BUILDING AMERICA®

Re: Docket No. FD 36854, Union Pacific Railroad Company – Construction and Operation Exemption – in Matagorda County, Texas; Response to Information Request No. 1

25% PRELIMINARY PLANS
NOT FOR CONSTRUCTION

Enc. Figure 1 – Cultural Resources Study Area

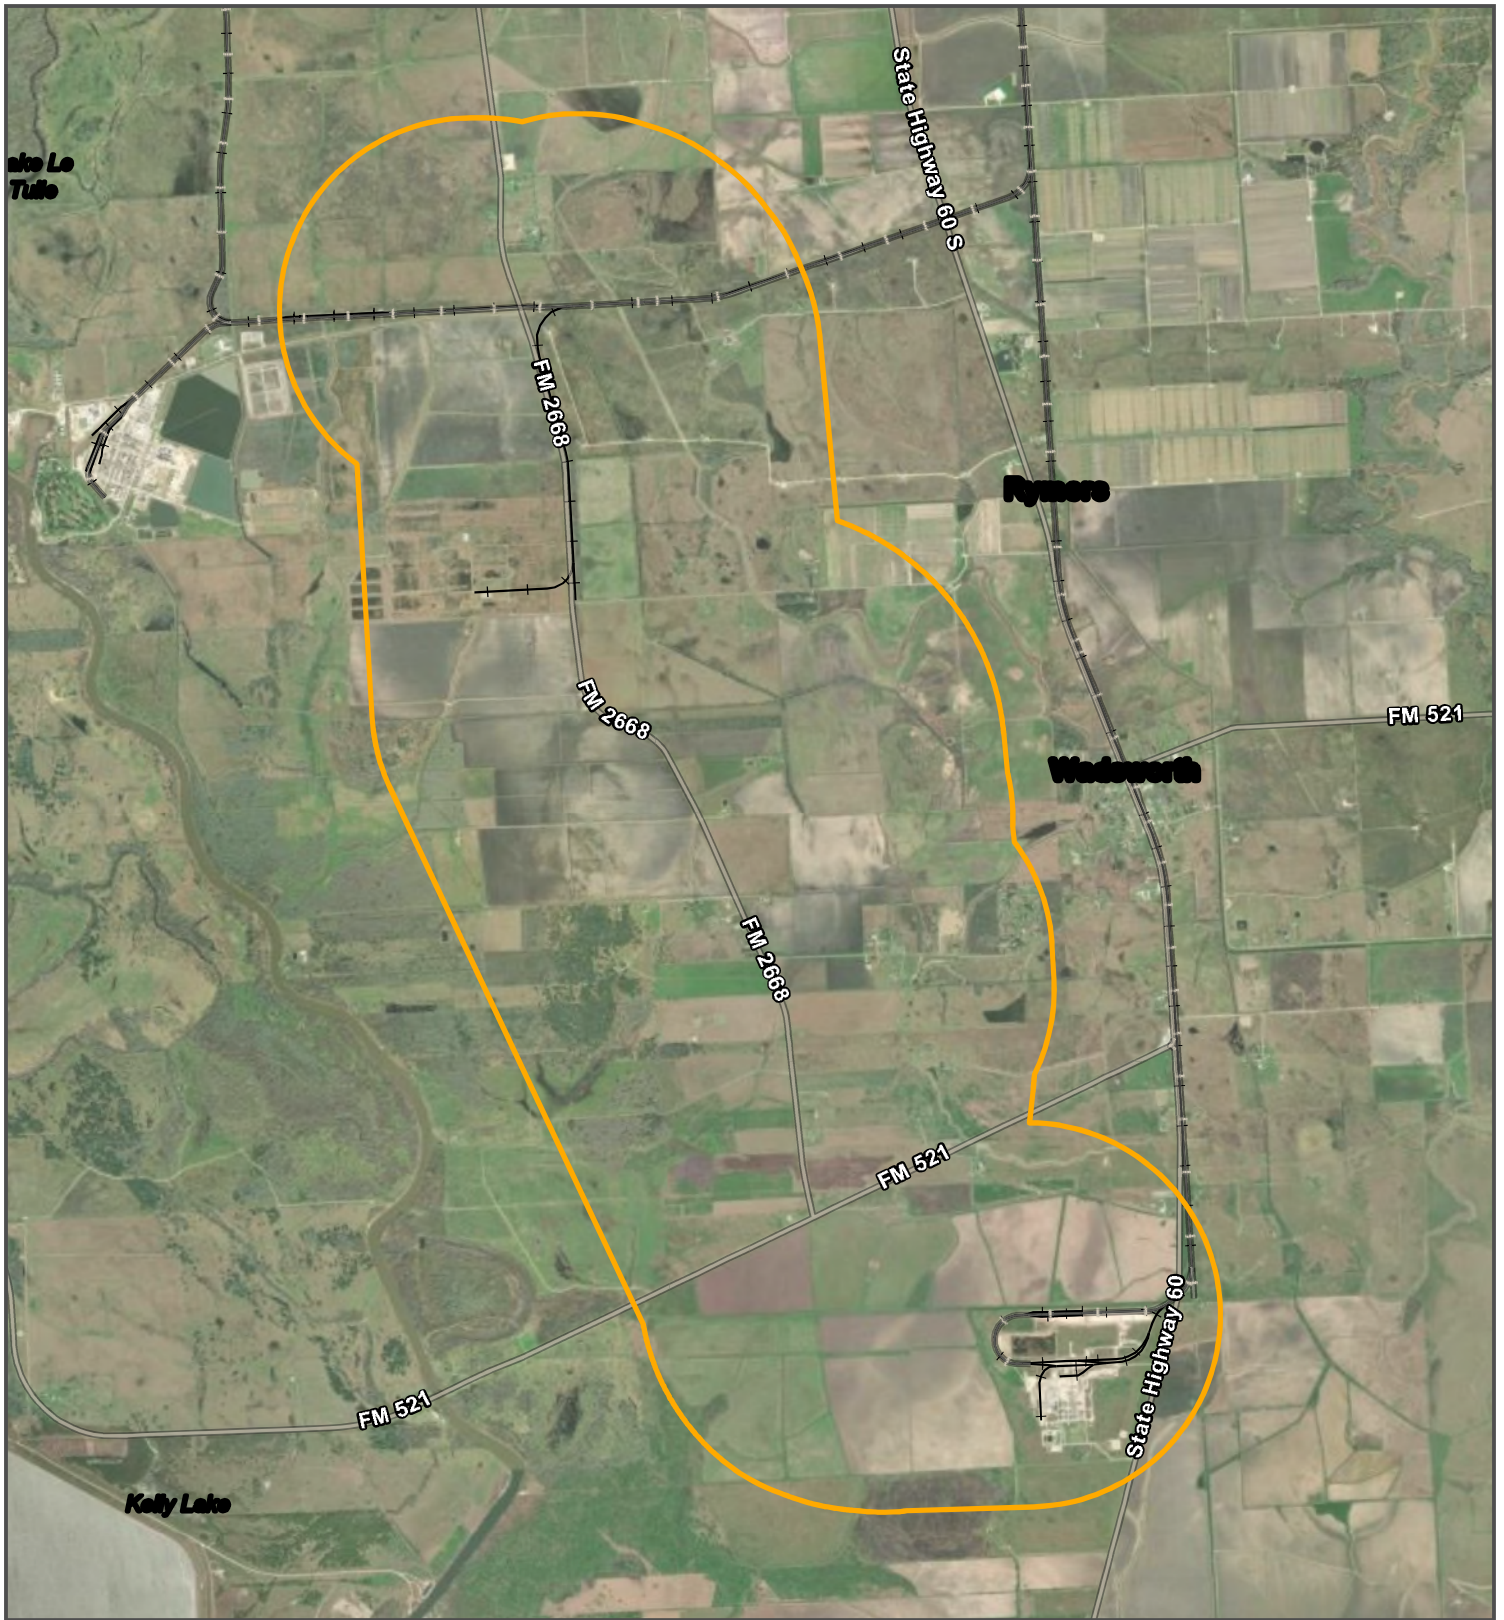
6.A. REQUEST: Provide any environmental studies or surveys previously conducted within or along the proposed project area, such as wetlands delineations, cultural resources surveys, or Phase I or Phase II Environmental Site Assessments, if available. If no such studies or surveys have been completed to date, please confirm this.

6.A. RESPONSE: A desktop review of the cultural resources has been completed for the project. See attachment titled "20250430_UPRR_Wadsworth_Cultural_Review" for additional details. No field work has been completed to date, but plans are being made to complete the field survey work in the summer of 2026 for biological resources and waterways & wetlands.

DWG TITLE: FM 3057 AT-GRADE CROSSING

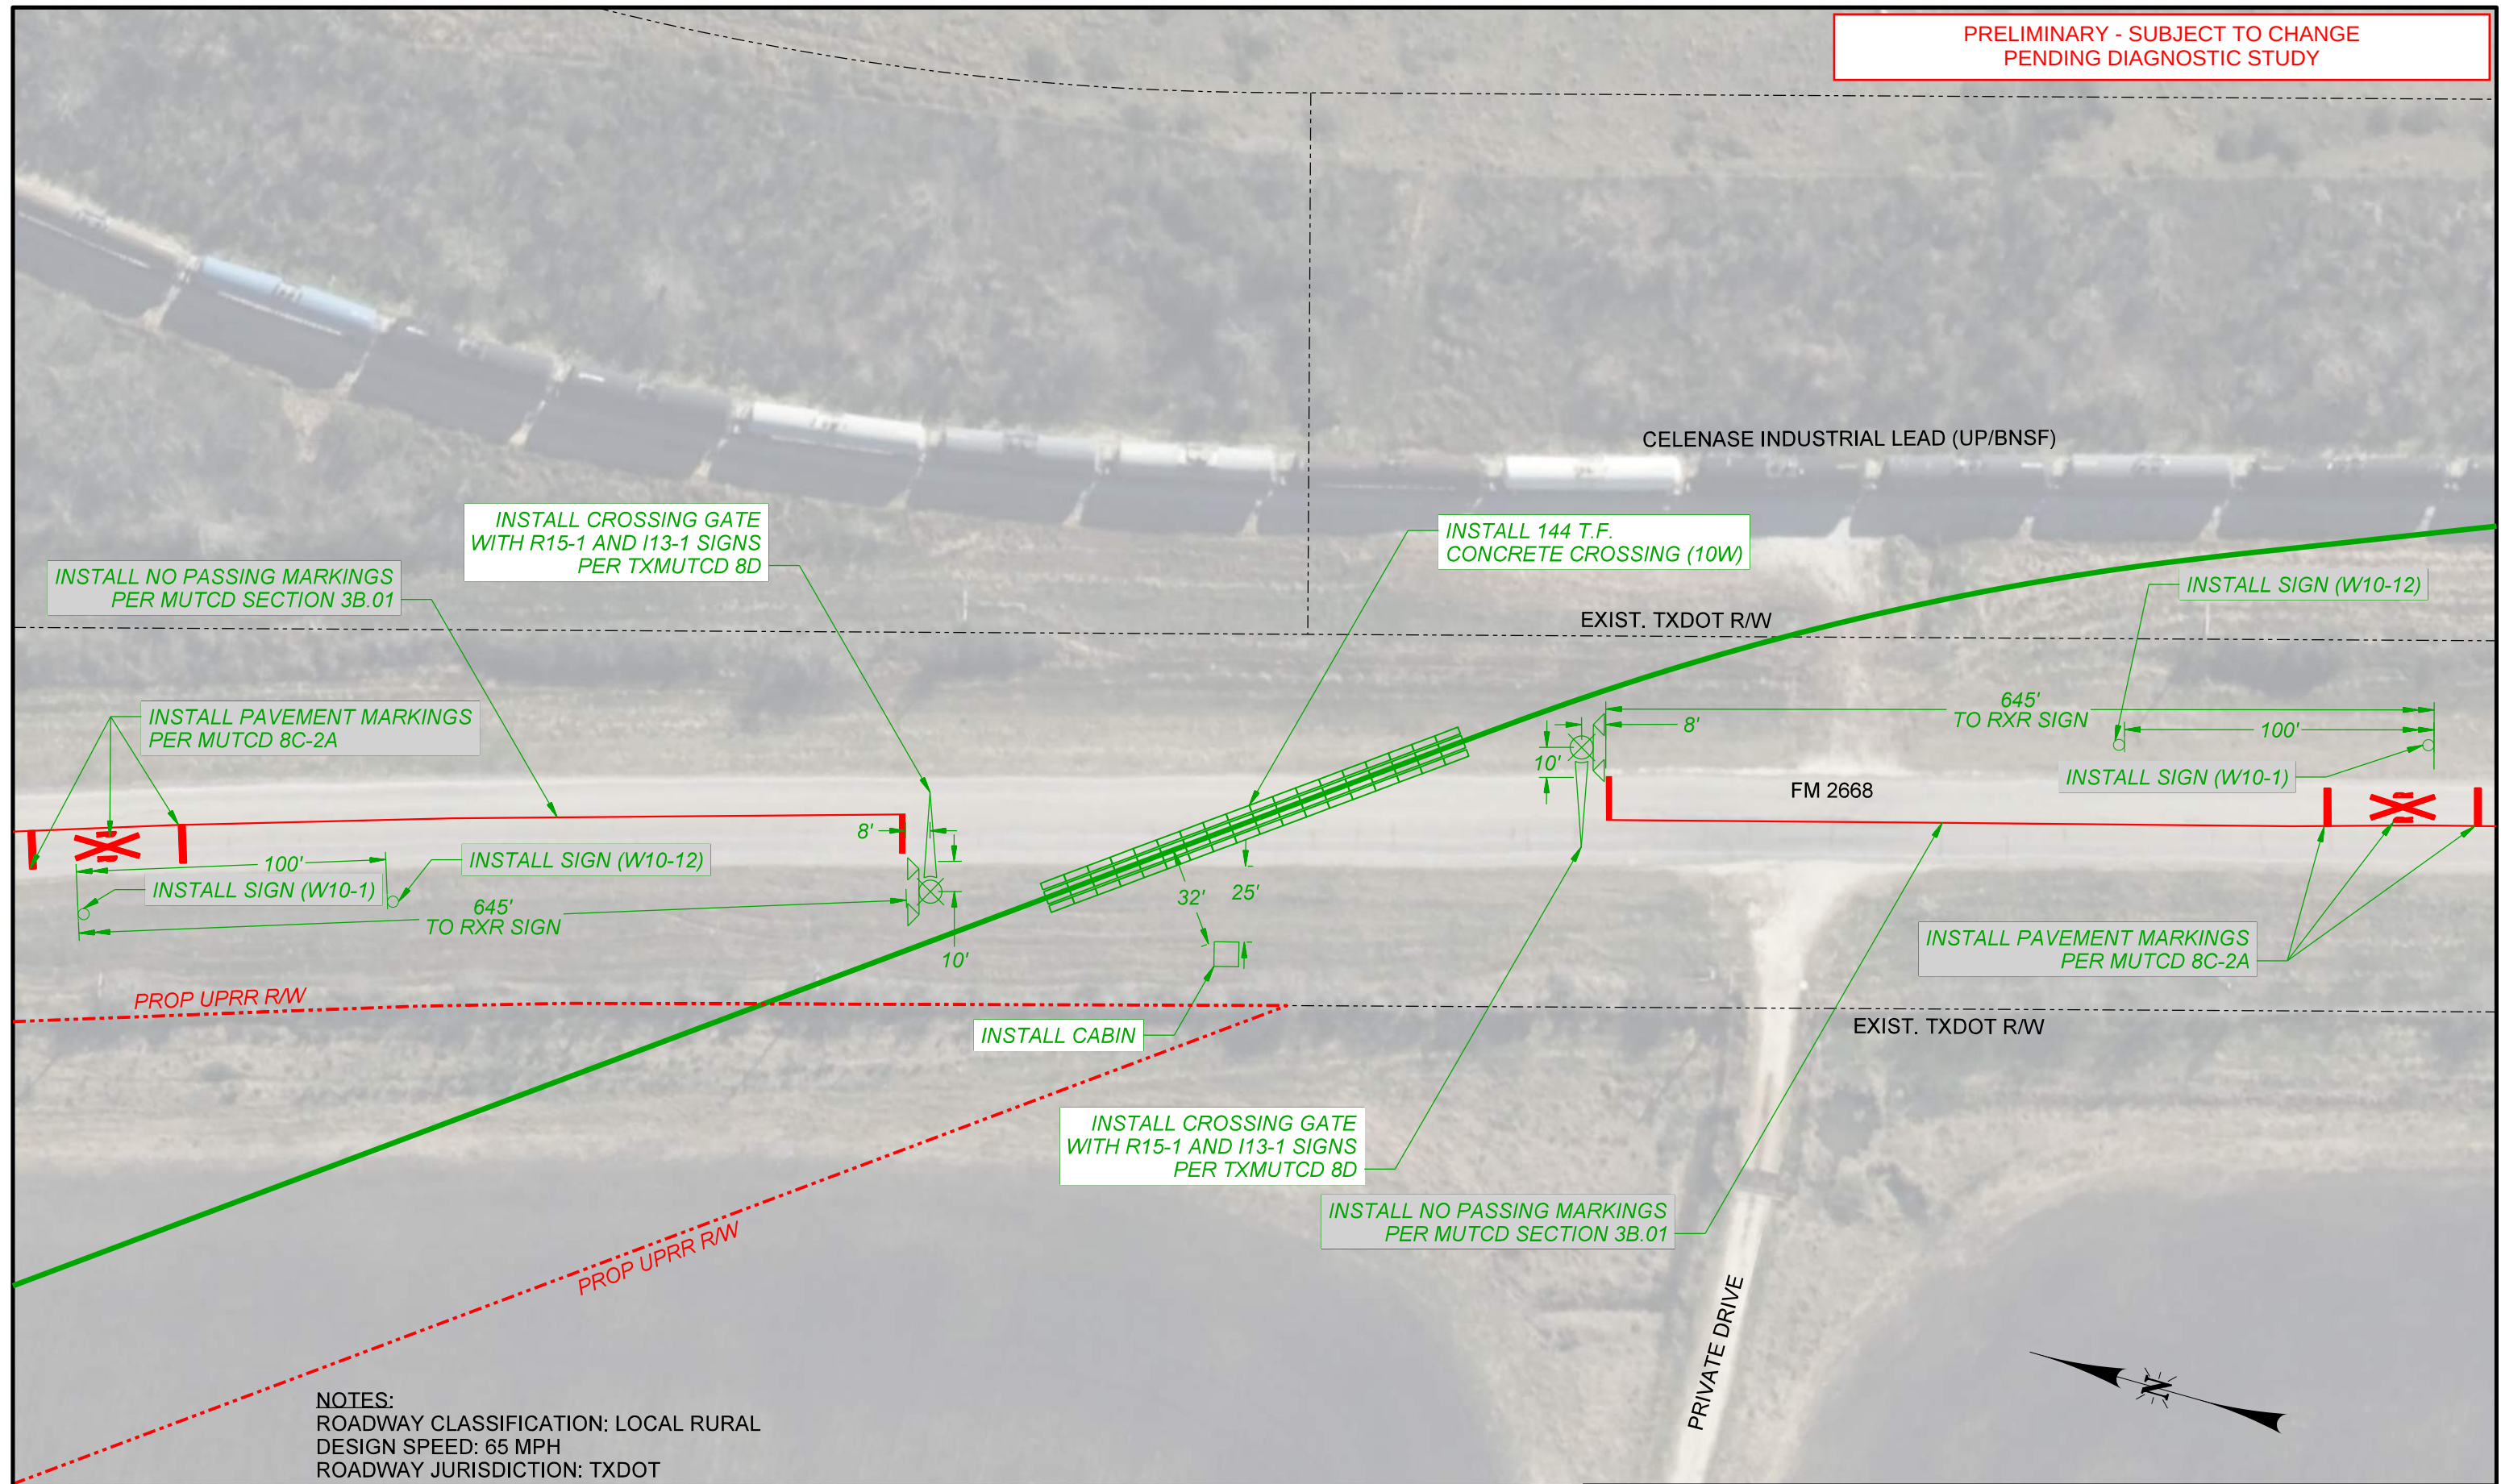
1.A.iii. REQUEST: Any at-grade or grade separated crossings.

1.A.iii. RESPONSE: Crossings will all be at-grade at FM 3057, FM 2668, Gilmore Road, FM 2078, and FM 521. See attached PDF titled "Wadsworth At-Grade Xings_25 pct."

HIF – Proposed location circled in red.

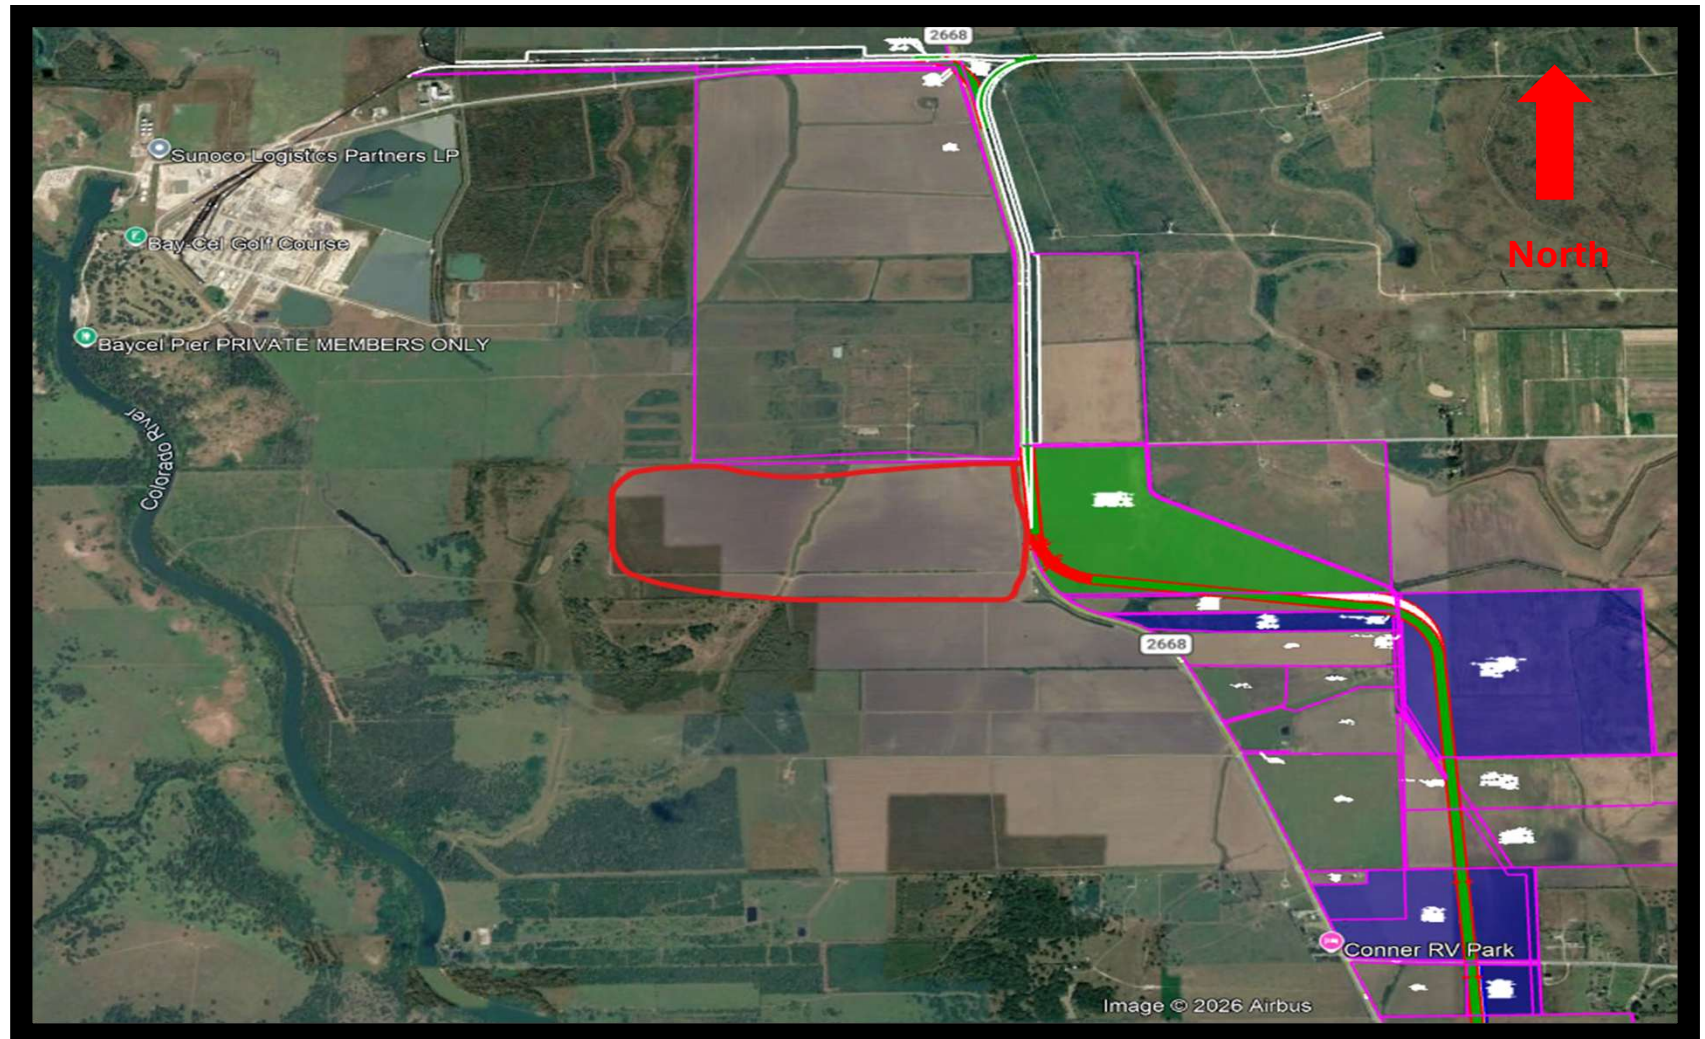
3.A. REQUEST: The Petition for Exemption and the Alternatives Report reference the potential to serve future rail-served customers or industrial development along the proposed line. Please identify any prospective shippers by name and provide their general locations, if available.

3.A. RESPONSE: UP is continuing to evaluate potential future rail-served customers or industrial development along the proposed line. UP has identified two potential opportunities with RCR Rail to construct an industrial park with rail car storage. Highly Integrated Fuels (HIF) is evaluating several locations for a new production site, one of the possible locations is located along the proposed line. See PDF attachments titled "RCR Rail location" and "HIF location."

RCR Rail – Proposed location referenced in **green**, LyondellBasell facility in **magenta**.

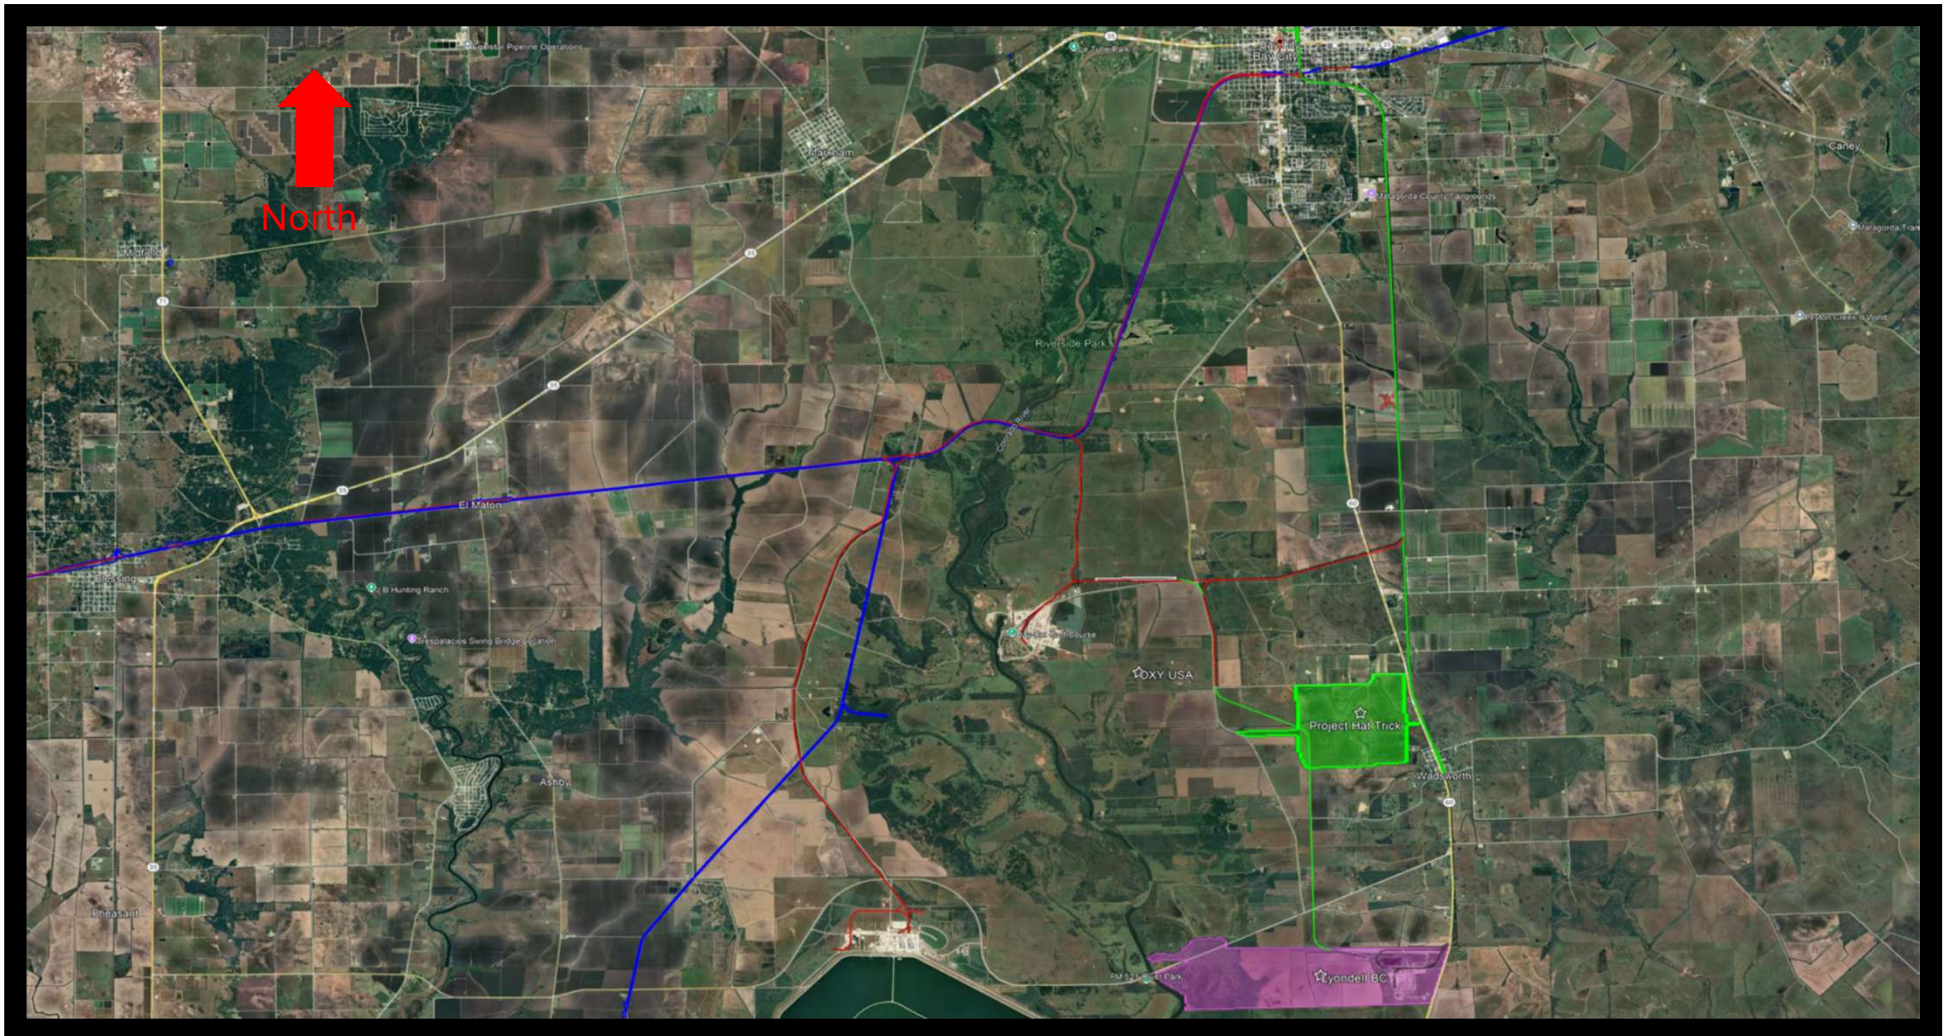
3.B. REQUEST: Provide a brief description and map of the approximate location, if available, of the potential industrial park located south of Gilmore Road and north of the LyondellBasell facility.

3.B. RESPONSE: An independent developer, RCR Rail, is proposing to construct an industrial park to locate new industries and to provide rail car storage for nearby customers. Similar to other facilities in the area, they are looking to create capacity and storage for customers in this vicinity of rapid customer growth. See attached PDF titled "RCR Rail location."
